POST TENDER CLARIFICATION CORRESPONDENCE VIA THE E-PORTAL

Date	Clarification ID	Title	Question	Answer
24.06.15	3	LRS Westminster Pier Question set (Q.2-Q.15)	Please find attached a number of questions in relation to the above requirement. Please respond ASAP, but by the latest Noon on 25 June 2015.	Please see attached response with attachments.

VOLUME 1 - PRE TENDER CLARIFICATION CORRESPONDENCE VIA THE E-PORTAL

Scale: 1:100
Date: 15.11.99
Drawing No: 4827/501

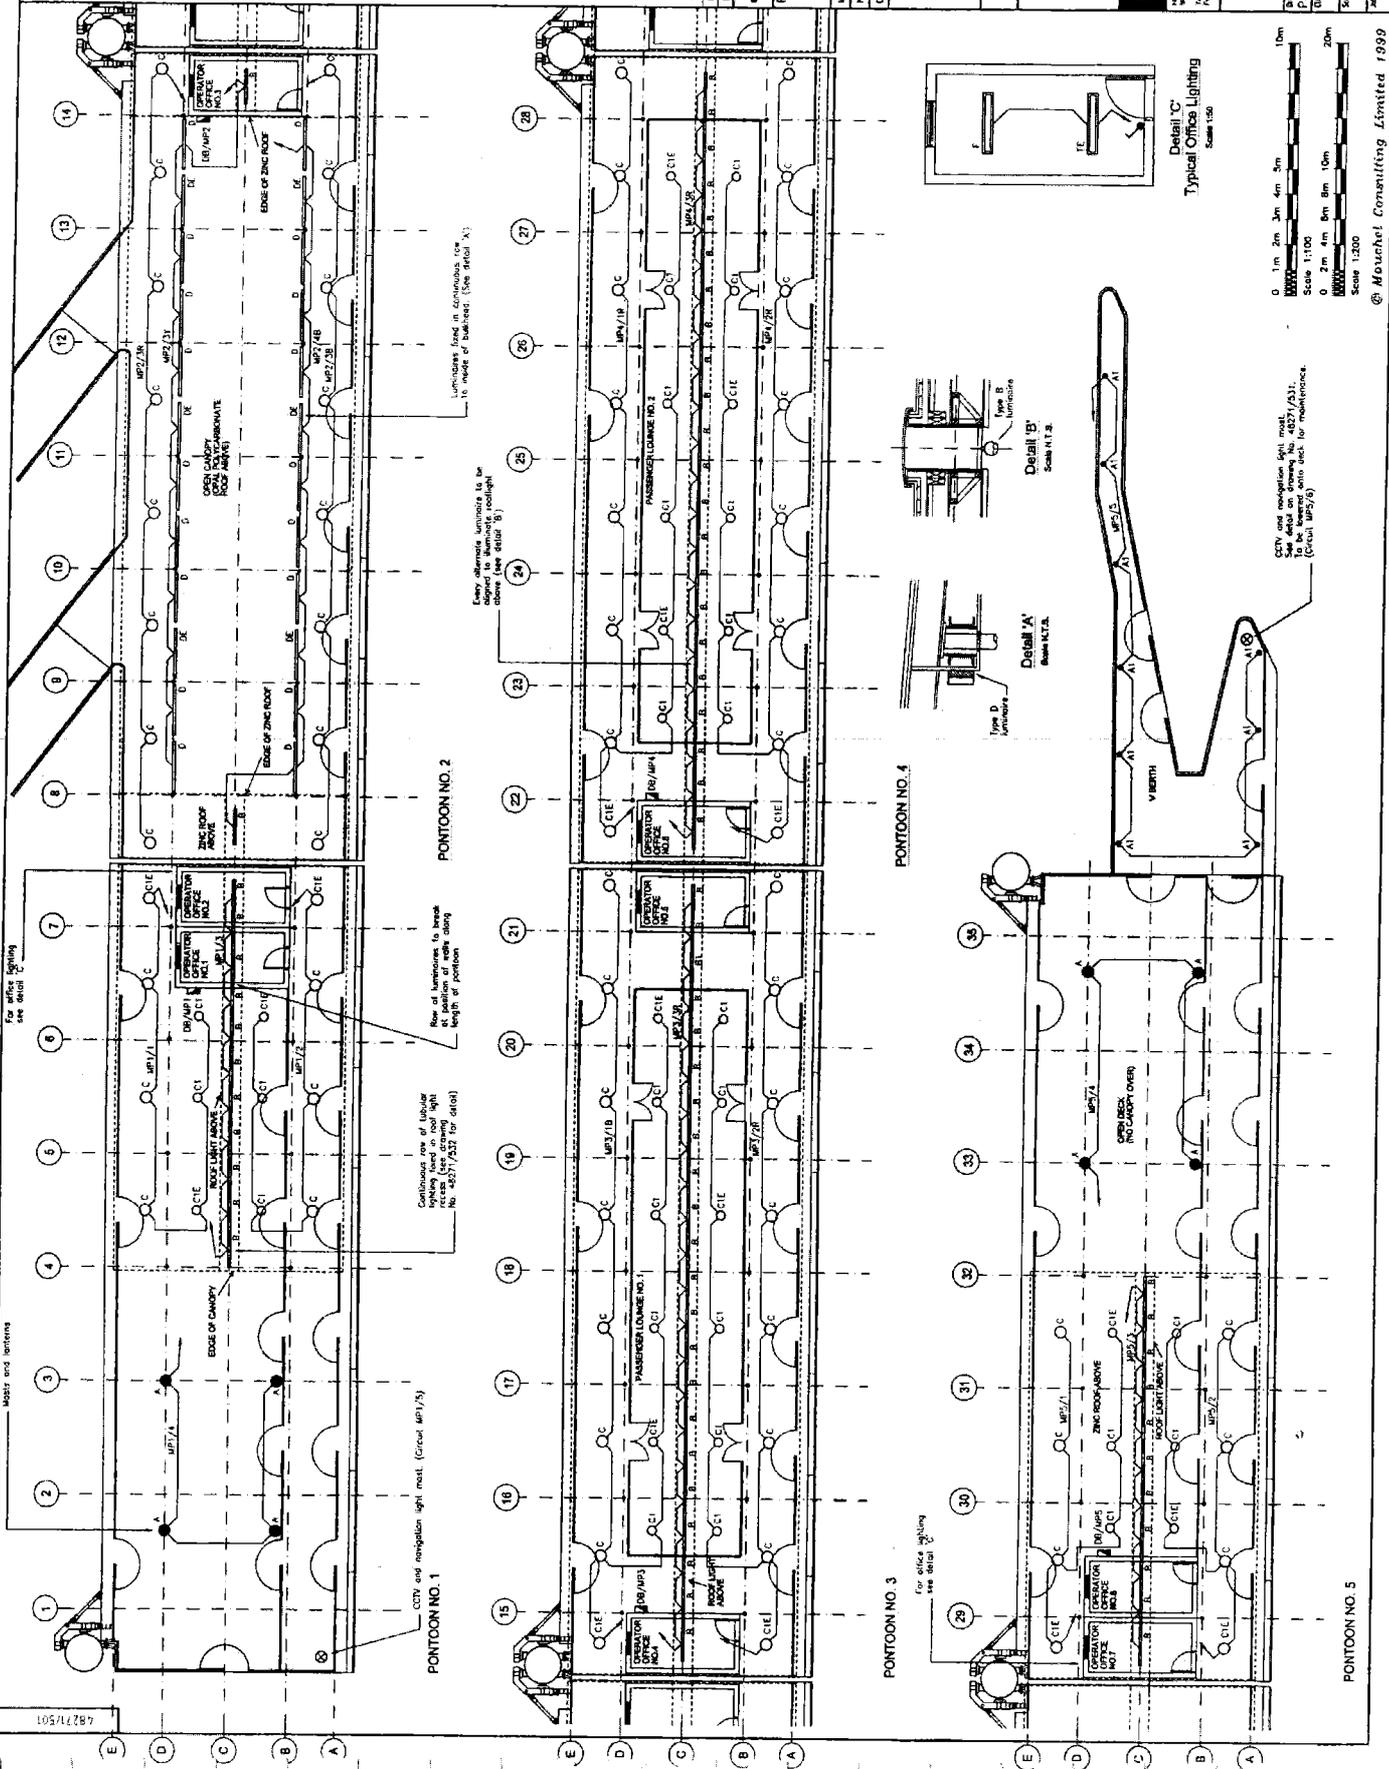
04.06.15	21	Lighting on new Pier	Please can you provide a drawing showing the lighting positions for the new pontoon.	The attached drawing 48271-501 shows the existing lighting layout. The layout on the new pontoon is expected to match, or be similar to, the lighting layout on pontoon number 4 (as labelled on the drawing).
